**Commercial / Residential Bldg.**  
 3544 - 3560 West 4th Avenue  
 Vancouver, B.C.

Development Permit Application  
3564-3580 West 41<sup>st</sup> Avenue

2. Address: 3580 West 41st Avenue  
DA: 404817  
Zoning: C-2  
Application Status: Complete  
Architect: Ramsay Worden  
Owner: Van City Enterprises  
Review: First  
Delegation: Doug Ramsey  
Staff: Anita Molaro

EVALUATION: [7 - 0] - Support

ELEVATIONS  
DP6

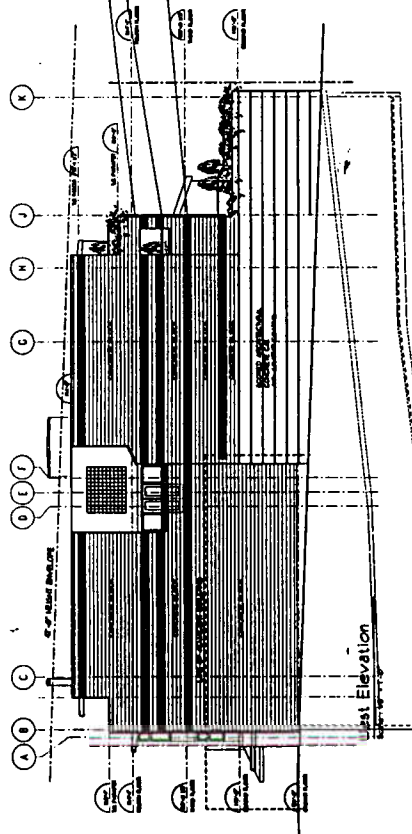
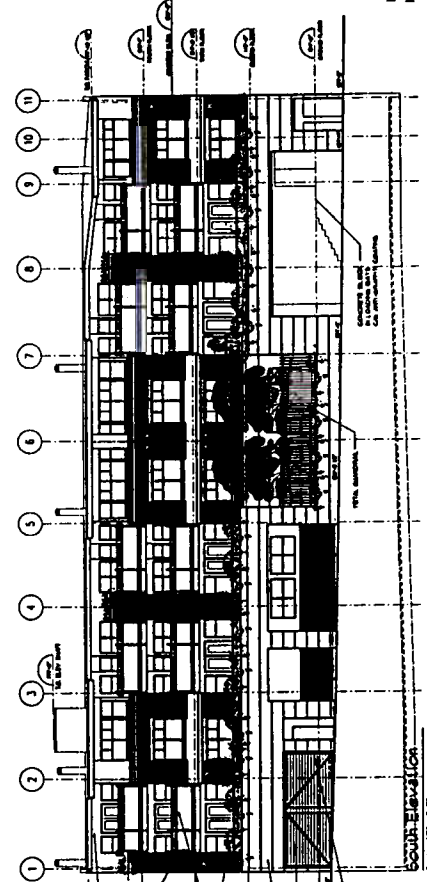
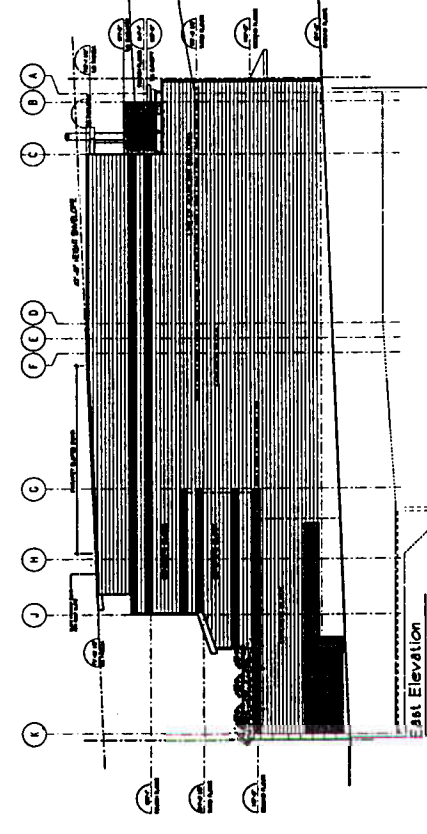
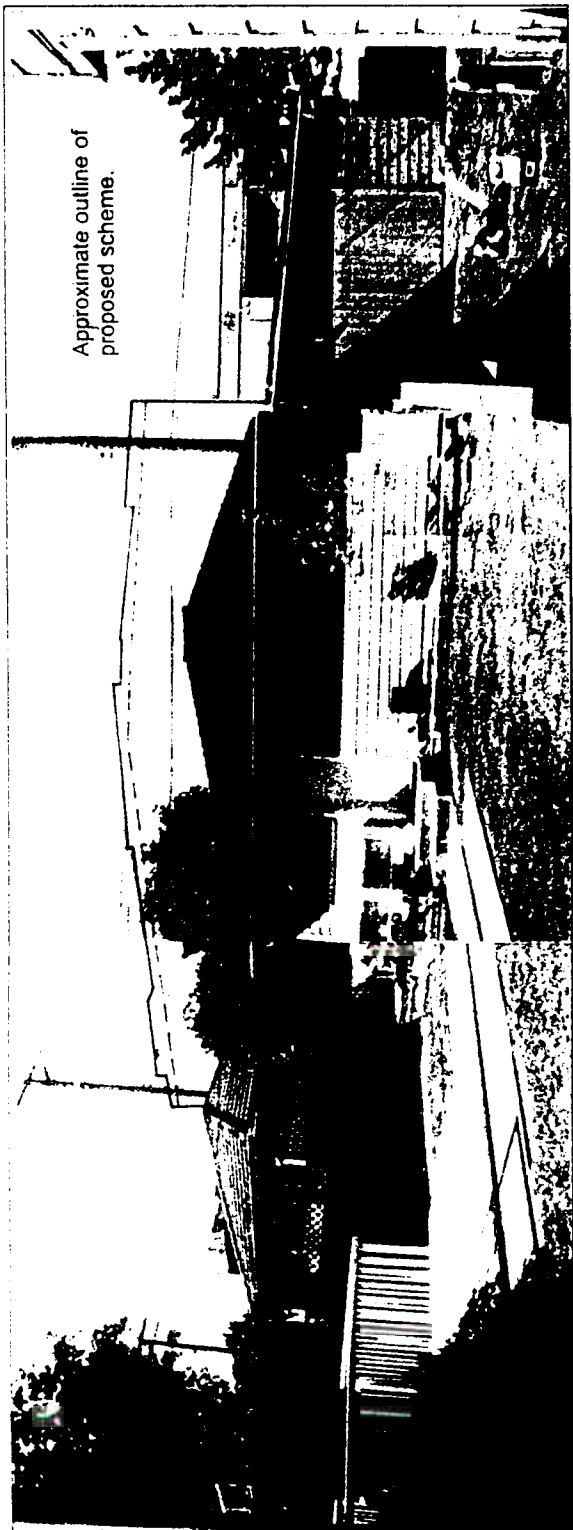
The Panel advised that they approved of the C-2 zoning as a vehicle for urban infill, and compared this project as a basic design that C-2 was intended to fulfill and that perhaps the City should be more relaxed about minuscule things like an extra foot or two at the one corner of a building, rather than expect a project to evolve into strange contortions in order to fulfill a zoning guideline. It was felt that the form of articulation on the street and the type of proposed materials and proportions were exemplary. Others commented that the stepped down corner of the roof at the rear should be straightened out, as it gave the appearance of a settlement problem. There were favourable comments about the proposed materials.

The Chair's summarized the Panel's support of this project and referred to the positive comments about C-2 infill strategy and that this project appeared to fulfill the promise of that strategy. He also referred to the approval of the signage. The Chair confirmed that the "settlement problem" of the southeast corner needed to be handled with a better resolution in spite of the height overage. However, it appeared that mechanical element on the roof appeared to be 'floating' and would require a revisit by the applicant; and although there were some concerns about views regarding the adjacent buildings, as well the commercial in the lane, it was generally felt that this project could be achieved.

Revised View Study  
Page 1

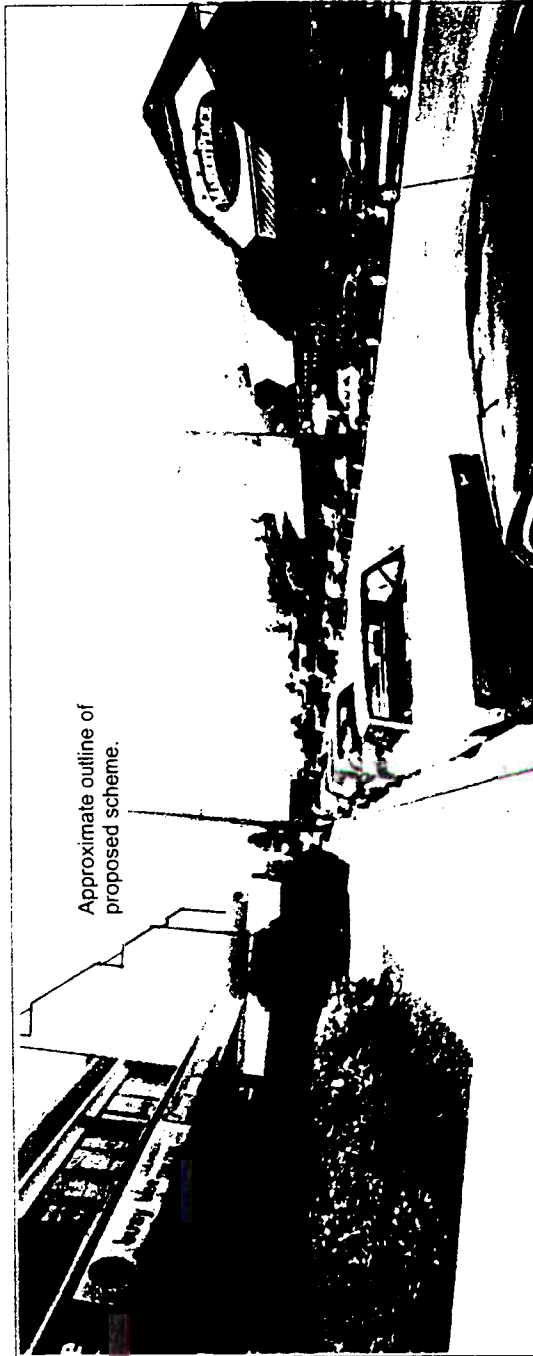
Adjusted floor to floor heights of Ground, First and Second levels decreases the apparent building height when viewed from the street.
